**Re: Request for More Information – NOI
Landfill Cap Investigation
46 Broad Street
Medway, Massachusetts**

On behalf of the Town of Medway Department of Public Works, Weston & Sampson Engineers, Inc. (Weston & Sampson / W&S) is hereby enclosing the requested responses to the following comments (shown in bold) issued via email on September 15, 2025:

FIGURE 5
MEDWAY LANDFILL
MEDWAY, MASSACHUSETTS
COMPOST FILTER TUBE DETAILS
NOT TO SCALE

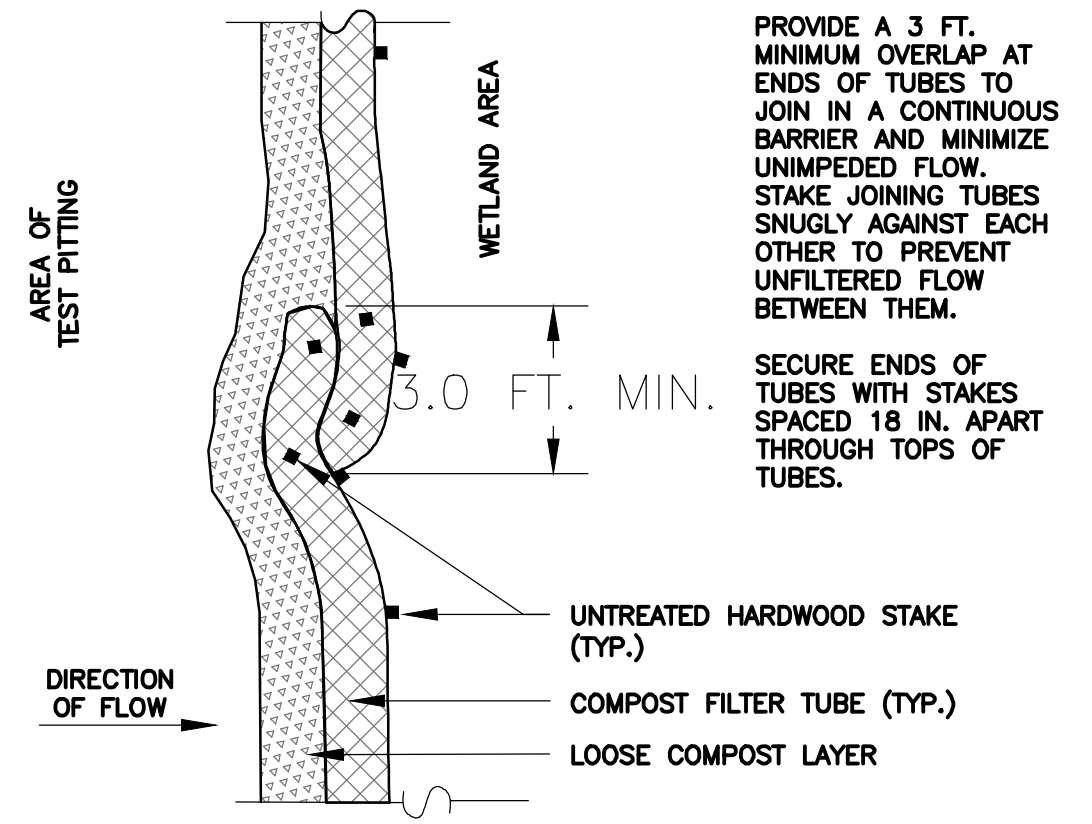
13. Revise Plans - Applicant to amend the erosion controls to be compost socks.

13. W&S Response: Figure 1 has been revised to show compost socks instead of straw wattles, and Appendix E of the NOI has been revised to show specs for compost socks instead of straw wattles.

FIGURE 1
Medway Landfill
Town of Medway
Medway, MA

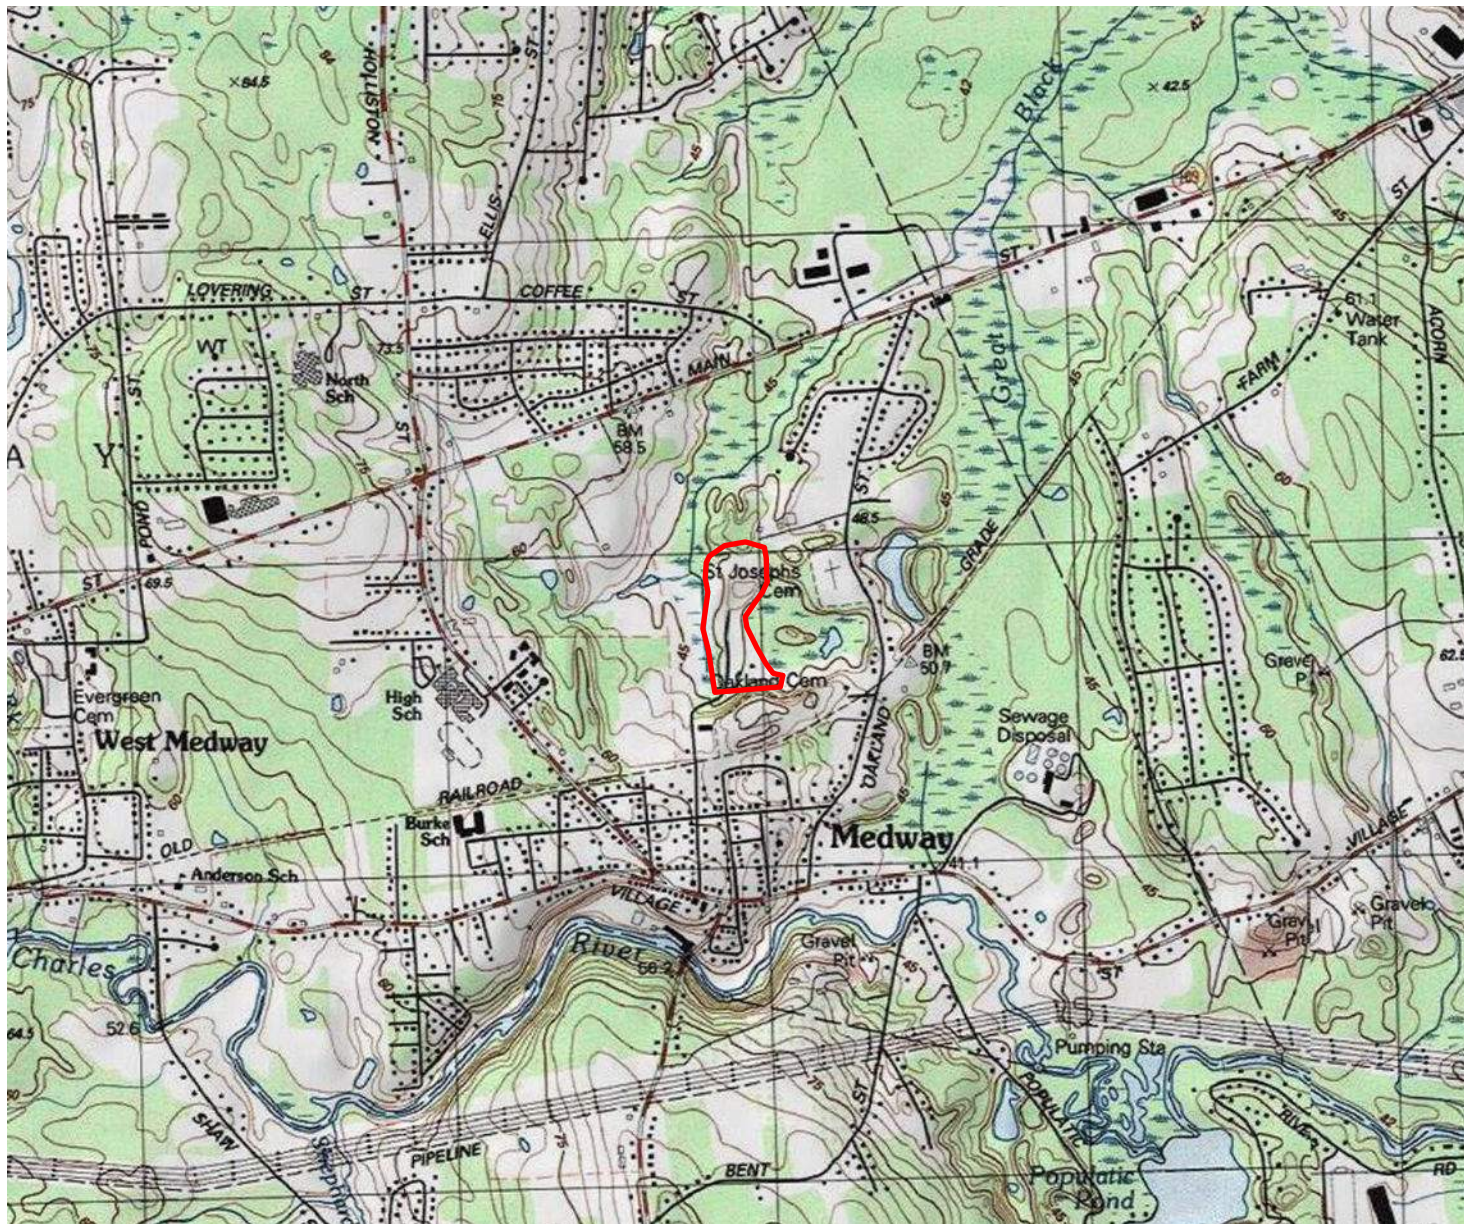
- 1. Provide Figure 4 in 24' x 36' with topo lines, test pits, and access routes, include wetland flagging on all sheets, this layer should be turned on for every map.**

- 2. Use the Agent's review of the Riverfront designation, StreamStats for the width of the stream, GIS for the center line, 7.25' to each side, and create a MAHW line, using 200' from this line.**

4. Provide calculations showing the 30% of the site is “degraded” – these need to be reviewed by the Commission for meeting this standard. Please show these areas on the map. This only to qualify under the 310 CMR 10.58(5), these areas shall be marked on the map, described and reviewed for consideration under the provision. Page 4-4.

9. Revise Figure 4 to show E&S not in BVW.

1. W&S Response: Figure 1 has been revised to include these items and is attached. Figure 1 also includes revised wetland lines based on the flag revisions and additions provided by the Agent on September 2, 2025. Revised delineation maps are also included with the attached revised wetland Delineation Report.

2. W&S Response: Figure 1 has been revised to use the Agent's review of the Riverfront designation to create a new MAHW line and 200' Riverfront Area Line. A revised Figure 1 is attached as well as a revised Wetland Delineation Report.

4. W&S Response: Total Riverfront Area within the site is approximately 165,850 sq ft. Degraded area within the total Riverfront Area is approximately 41,500 sq ft. Based on the new MAHW line and 200' Riverfront Area line, approximately 25% of the Riverfront Area within the site is degraded. These areas have been identified and quantified in the revised version of Figure 1 attached.

9. W&S Response: Figure 1 has been revised to show adjusted E&S control outside BVW.
